2015 ILO Written NRC Exam High Miss Question Analysis

WC-2015-11

Subj: Post-Examination Analysis and Comments

Excure NIS Ranges

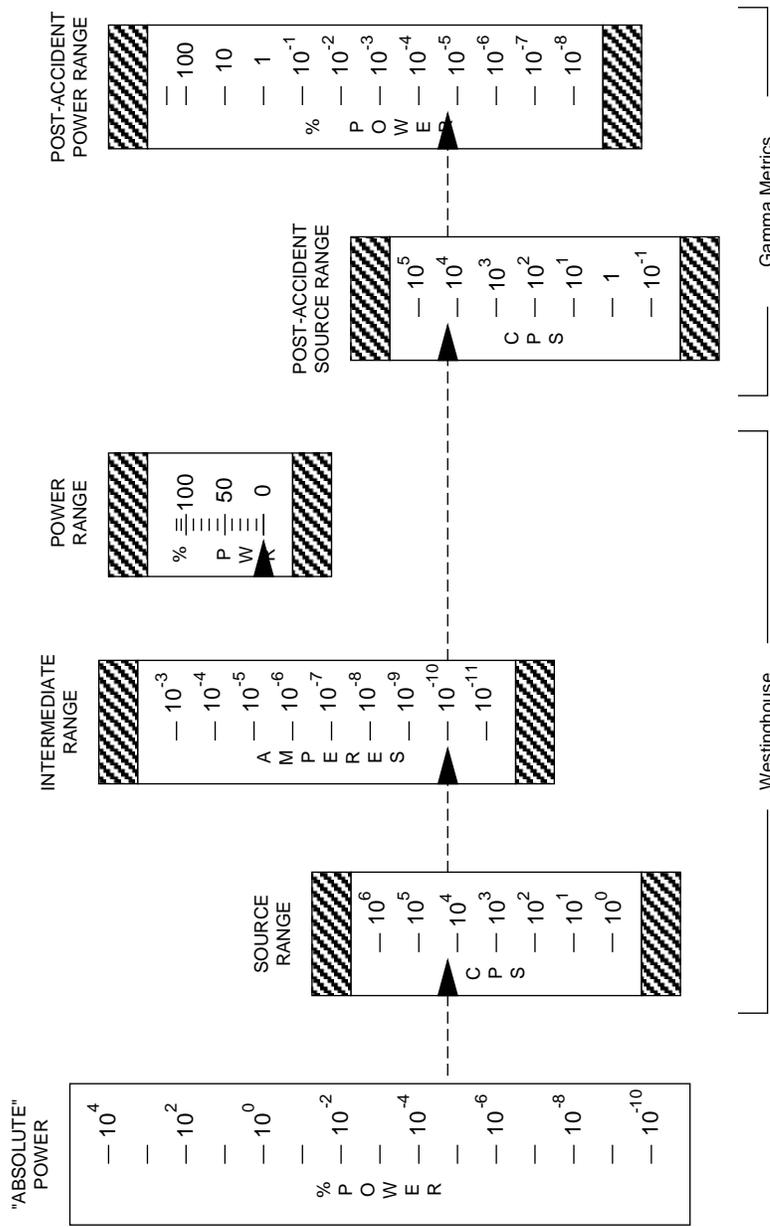
Analysis: 3 of 15 students selected 'C.' They recognized SE N-31 was reading low, but incorrectly stated the reactor startup could continue. OFN SB-008, INSTRUMENT MALFUNCTIONS, Attachment P, Step P7 directs stopping startup if in progress. 6 of 15 students selected 'D.' They selected SE N-32 was reading high; failing to recognize that for proper overlap, SE N-31 was reading a decade low, but recognized reactor startup could NOT Continue. The concept of instrument overlap was taught in SY1301501, Excure Nuclear Instrument System, Section 1.2 Detectors. The concept of actions taken for instrument failures was taught in LO1732418, OFN SB-008 INSTRUMENT MALFUNCTIONS, Objective 3. Question is valid and no changes are required. **REMEDIATION:** Discuss the missed exam question concepts during exam review.

See Figure 1 from OFN NN-021 below:

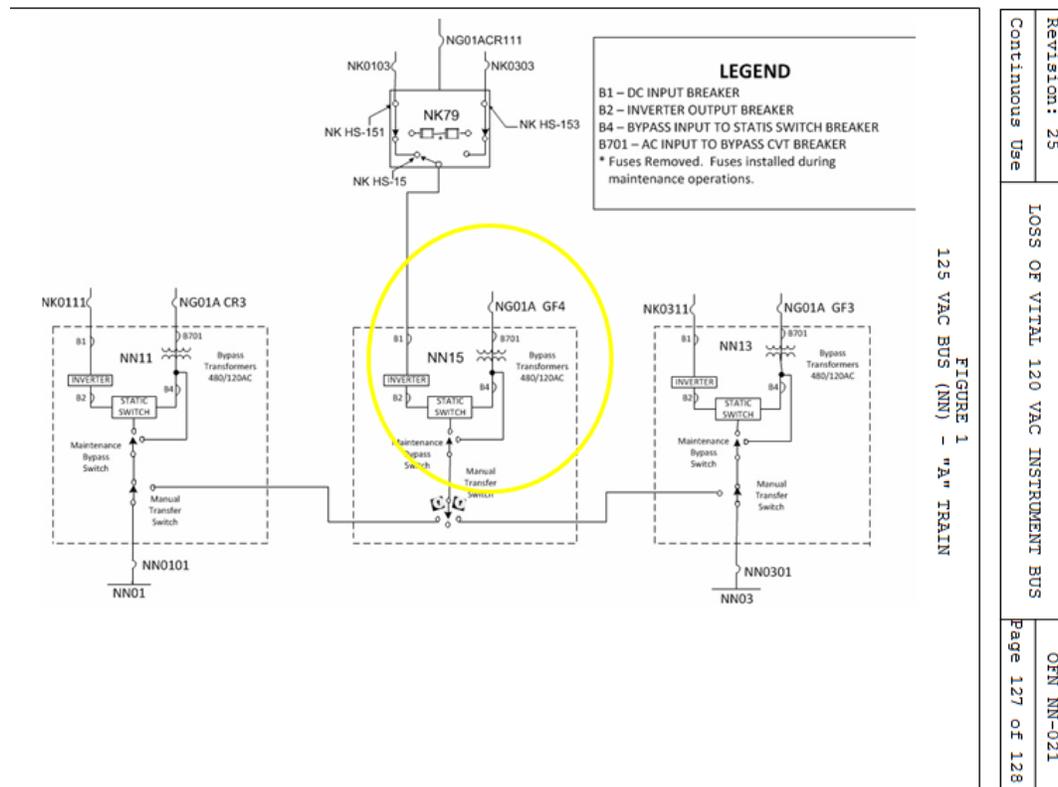
Analysis: 3 of 7 students selected 'B' "1. OFN NN-021, LOSS OF VITAL 120 VAC INSTRUMENT BUS 2. OPERABLE" – Right procedure but missed the OPERABILITY determination. 1 of 7 students selected 'C' "1. OFN NK-020, LOSS OF VITAL 125 VDC BUS NK01, NK02, NK03 AND NK04 2. INOPERABLE" – Wrong procedure, but right OPERABILITY determination. Students were taught applicable Technical Specifications in SY1506300, DC and Instrument Power, Class 1E, Lesson Plan, Objective 5. Students were taught procedure entry condition concepts in LO1732430, OFN NN-021, LOSS OF VITAL 120 VAC INSTRUMENT BUS Lesson Plan, Objective 1. Question is valid and no changes are required.

REMIEDIATION: Discuss the missed exam question concept during exam review.
